Queenstown Lakes District Proposed District Plan

Variation 1 - Arrowtown Design Guidelines 2016

Section 42A Hearing Report For Hearing commencing: 7 November 2016

Report on submissions and further submissions
Variation 1

- ii. New Town Plan 2, page 15 of ADG 2016 (identified with strike through the green former Jopp Street Neighbourhood area) be replaced with amended New Town Plan 2, page 15.

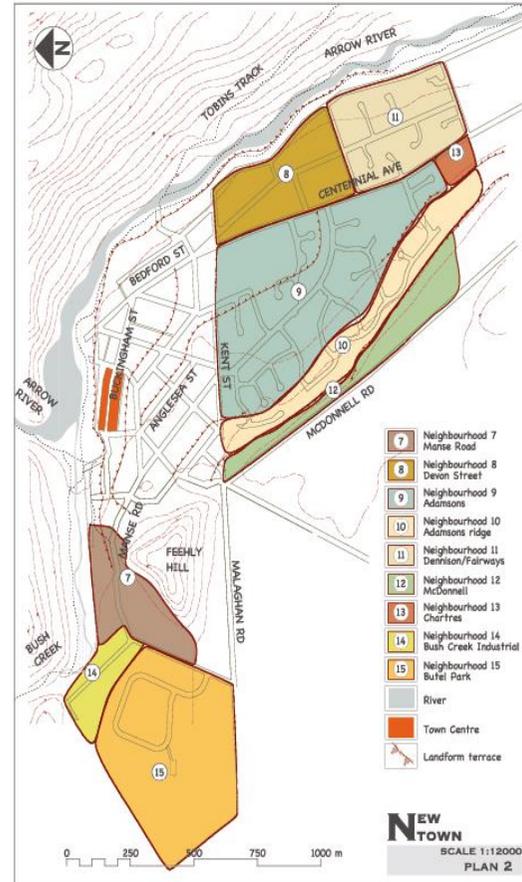
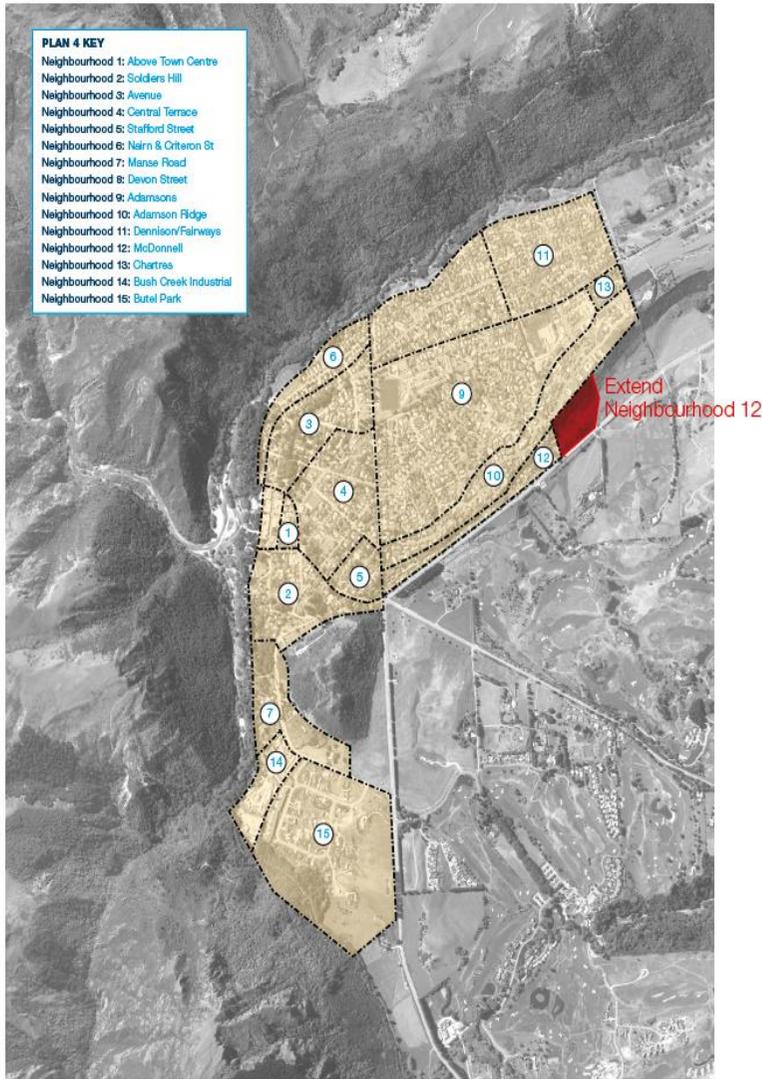
12.4. Submitter 3 (Elizabeth Hanan) notes that the map on page 4 of the ADG 2016 identifies the Jopp Street extension as being outside of the boundary.⁵⁰ Similar issues are raised with Plan 2 on page 15 of the ADG 2016.⁵¹ Further, the submitter notes that Plan 4 (page 19) requires updating as McDonnell Road now has a defined urban boundary (PC30 and PC29) and the plan needs updating to reflect this.⁵²

12.9. The amendments sought to the map on page 4 of the ADG 2016 and Plan 2 on page 15 of the ADG 2016 by Submitter 3 (Elizabeth Hanan) are accepted. The Jopp Street extension sits outside the Arrowtown urban growth boundary and was a carry-over from the earlier ADG 2006. As such, the relief sought by the submitters are accepted.

Plan 4 - Setting out Old Town and New Town Neighbourhood Areas

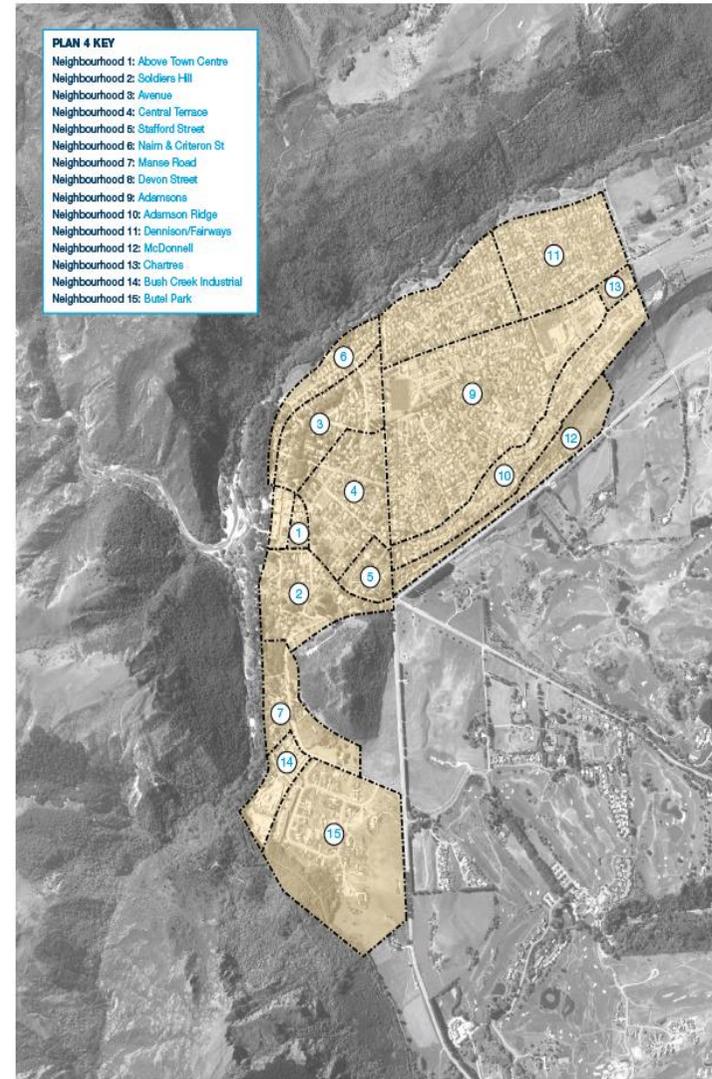
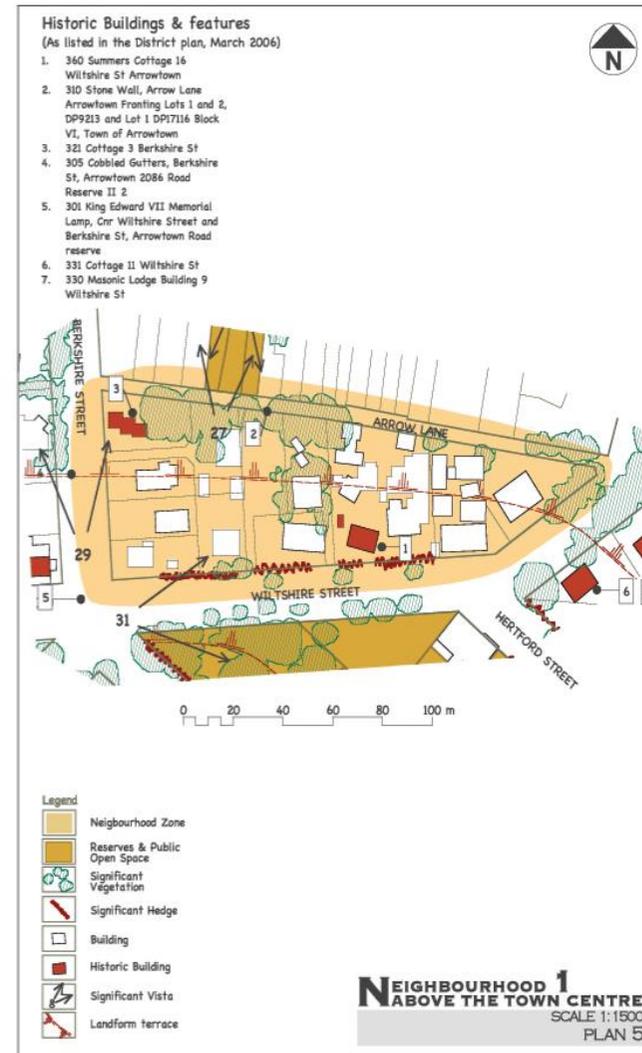
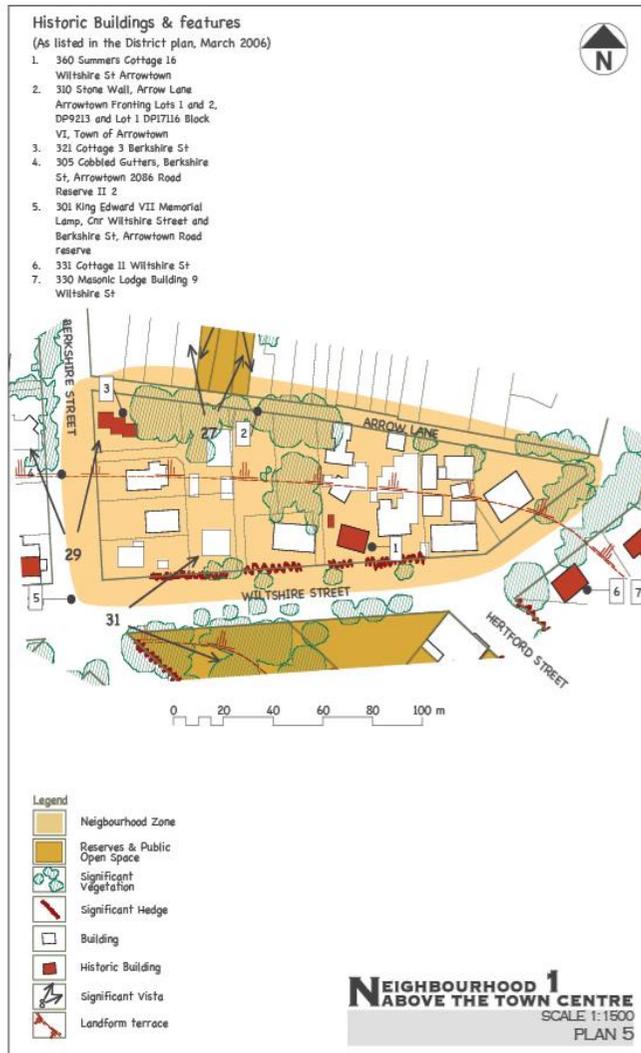
- iii. New Town and Old Town Neighbourhood Plan 4, page 19 of ADG 2016 (identified with an extension of the Neighbourhood 12 area to follow urban growth boundary) be replaced with amended New Town and Old Town Neighbourhood Plan 4, page 19.

- iv. Neighbourhood 1 – Above the Town Centre, Plan 5, page 21 of ADG 2016 be replaced with amended Neighbourhood 1 – Above the Town Centre, Plan 5, page 21 of ADG 2016.

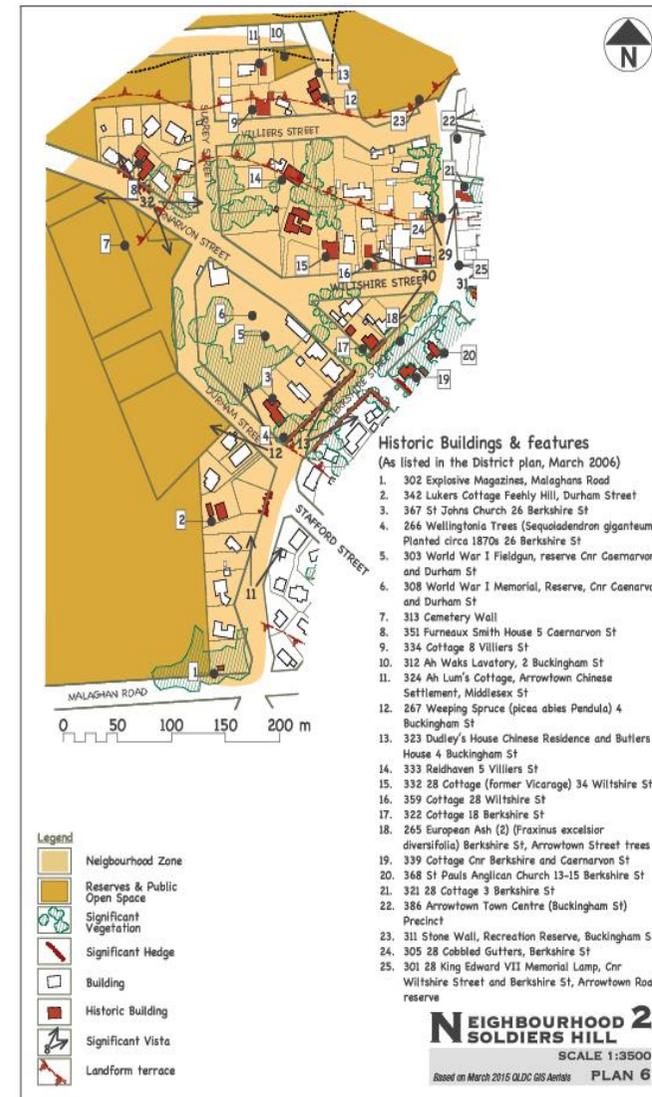
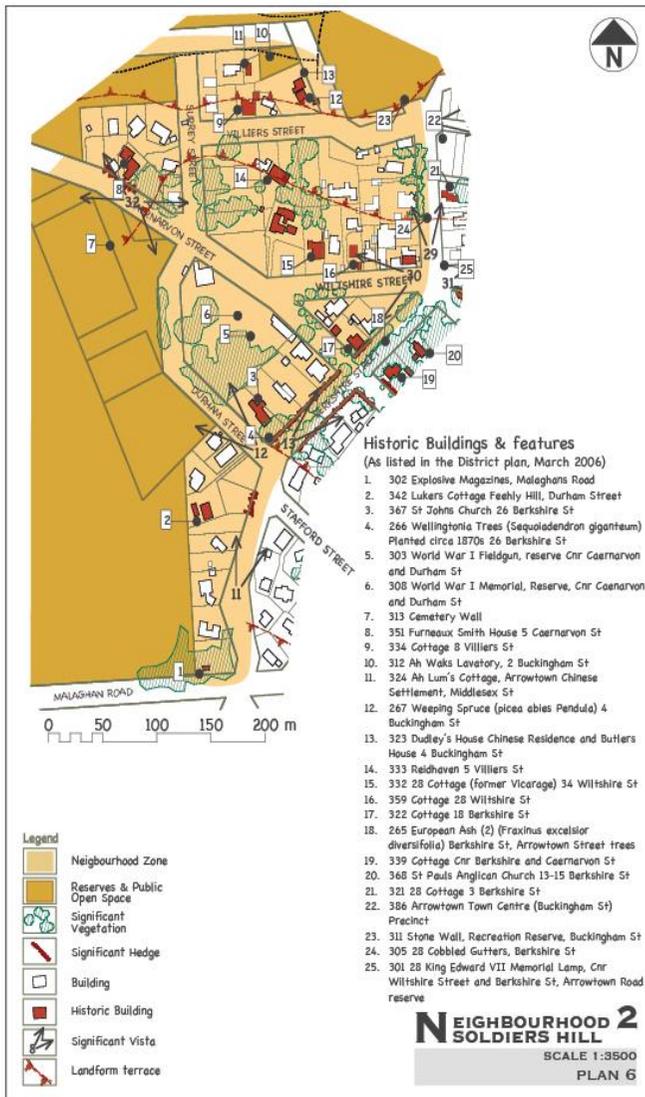
- i. Neighbourhood 1 – Above the Town Centre, Plan 5, page 21 of ADG 2016.

ix. Town Centre – Plan 20, page 51 of ADG 2016 be replaced with amended Town Centre – Plan 20, page 51 of ADG 2016.

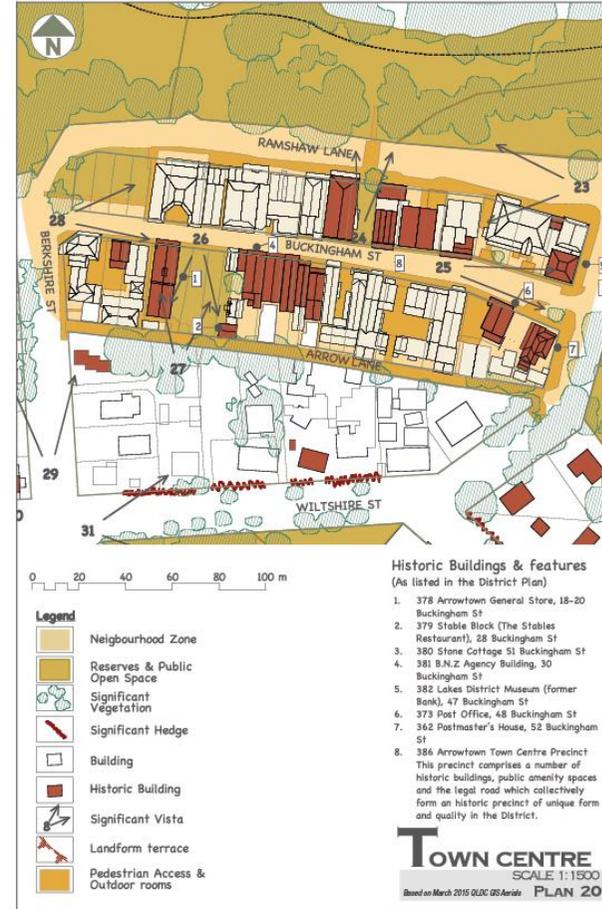
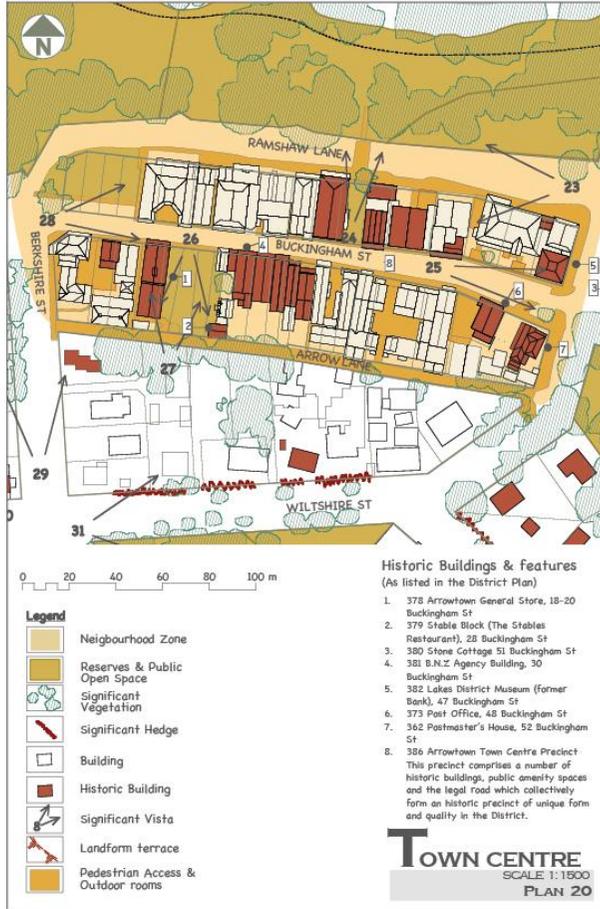
- i. Section 2.3.3-2.3.3 New Town - add under threats – lack of a footpath.68
- ii. Section 3.1-3.1 Conservative Heritage Character - Plan 20 page 51 new buildings in the Post Office development are shown as heritage buildings – delete.69
- iii. Section 3.2-3.2 Apply Best Practice Heritage Conservation - Remove the photo of historic cottage which is out of context for Town Centre Guidelines.70
- iv. Section 3.4.5-3.4.5 Guidelines: The Lanes and Buckingham Street - 3.4.5 (g) – delete 'Lighting will be installed in Arrow lane' as lighting has been installed.71
- v. Section 3.4.5-3.4.5 Guidelines: The Lanes and Buckingham Street - 3.4.5 (h) remove text about Willow trees that have been removed from Arrow Lane.72
- vi. Section 3.4.5-3.4.5 Guidelines: The Lanes and Buckingham Street - 3.4.5 (i) delete powerlines underground – this work is completed73

MDRZ & LDRZ-Figure 4

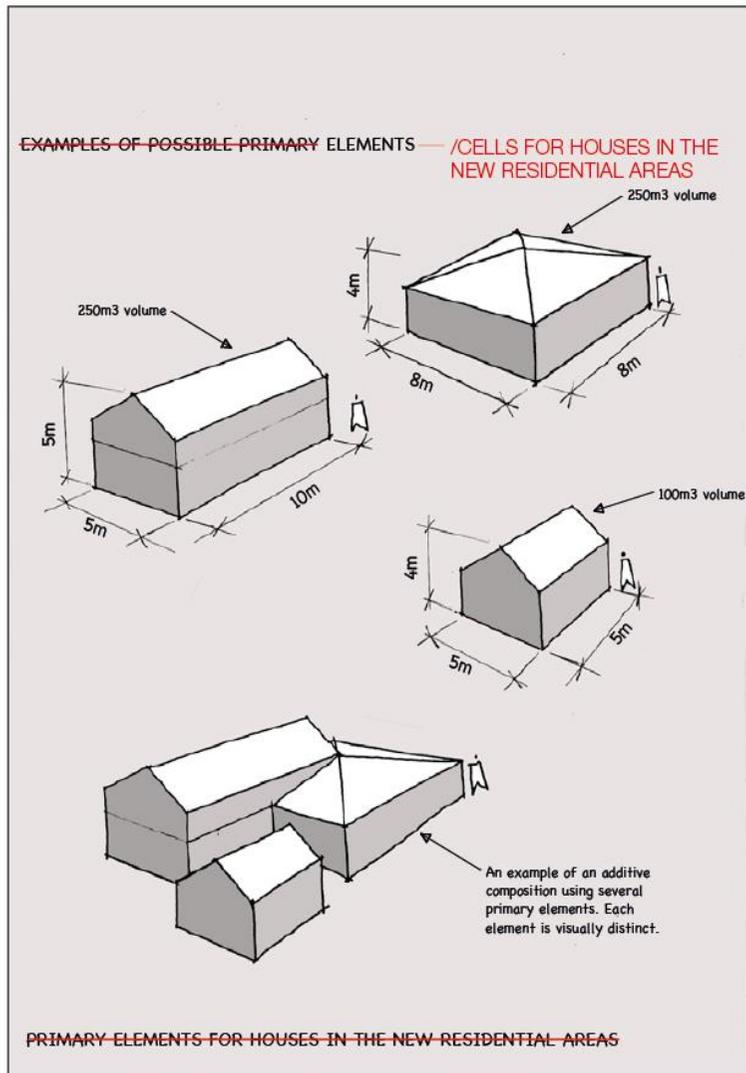
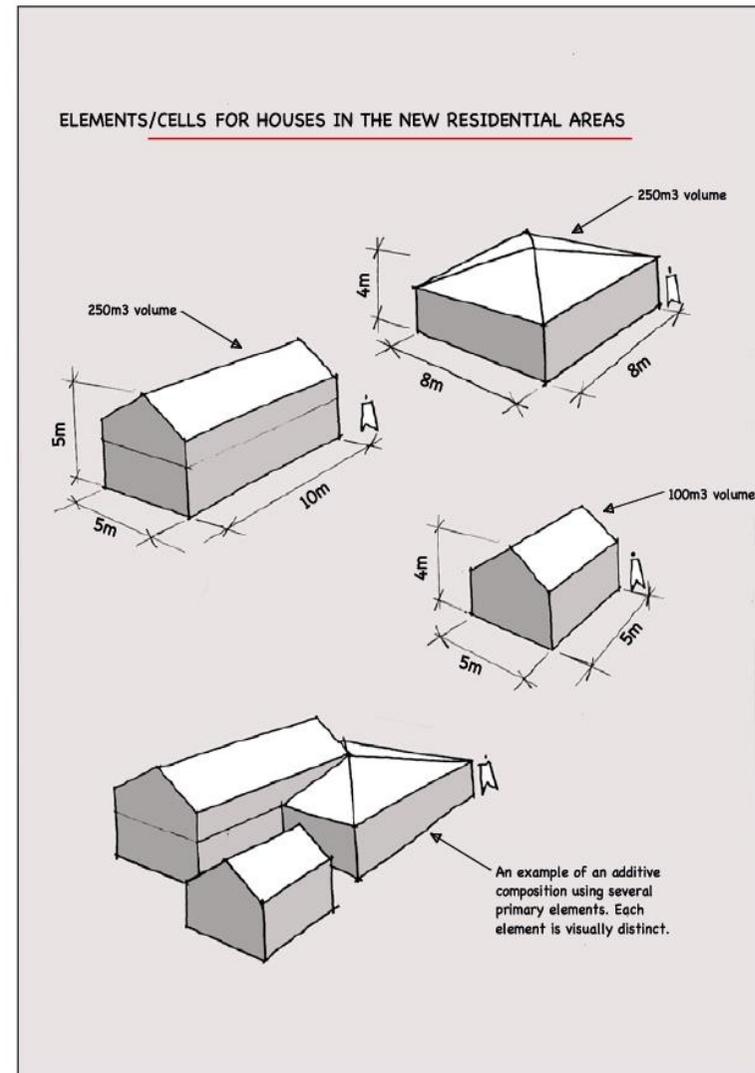
- vi. Amend MDRZ and LDRZ –Figure 4, page 118 of the ADG 2016 to remove reference to 'Primary elements' and amend to refer to 'element/cells' for houses in the New Residential Area (reflected on page x of this evidence);

- ii. Amend MDRZ and LDRZ –Figure 4, page 118 of the ADG 2016 to remove reference to 'Primary elements' and amend to refer to 'element/cells' for houses in the New Residential Area.

MDRZ-Figure 1
(Figures 1, 2 and 3 have been designed utilising the Proposed District Plan bulk and location standards, and therefore accurately reflect the potential built form that could be generated within the proposed MDRZ)

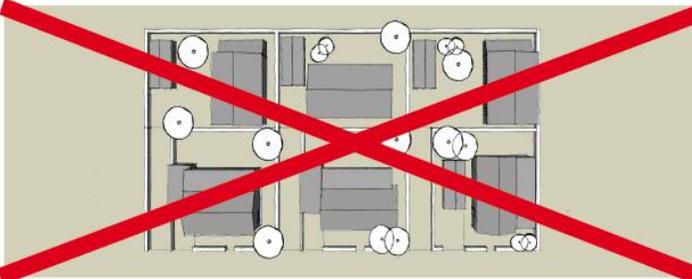
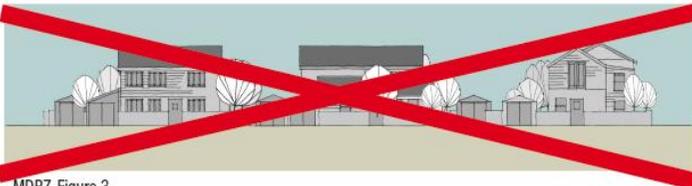
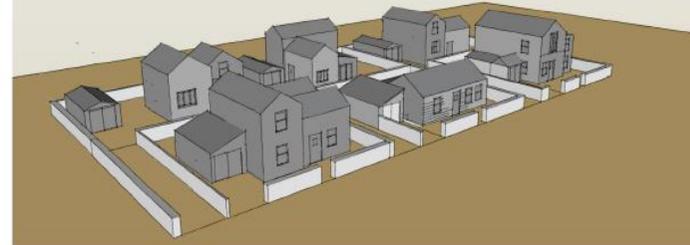
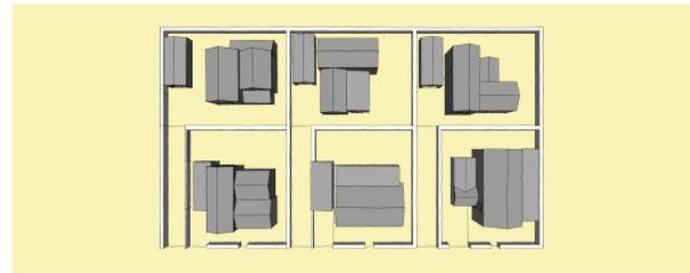
12.39. Rather than adopt the outcomes sought by Mr Blakely, which are not considered effective or efficient, Mr Knott and I recommend changes to the introductory paragraph to Section 4.8 and to Guideline 4.8.2.3 to provide greater guidance around ensuring that the shape and form of new buildings within the MDRZ and LDRZ are broken up and that individual built elements/cells sizes is limited in scale to better reflect the shape and form of the cottage form found within the ARHMZ. This means that that the guidelines will better direct design outcomes which seek to reduce the overall mass of built element into smaller individual components, while maintaining the overall footprint for development within the MDRZ and LDRZ. Mr Knott has revised MDRZ Figures 1, 2 and 3 on page 102

- iii. Amend MDRZ Figures 1, 2 and 3 on page 102 of the ADG 2016 to better reflect the individual elements/cell sizes anticipated within the MDRZ.
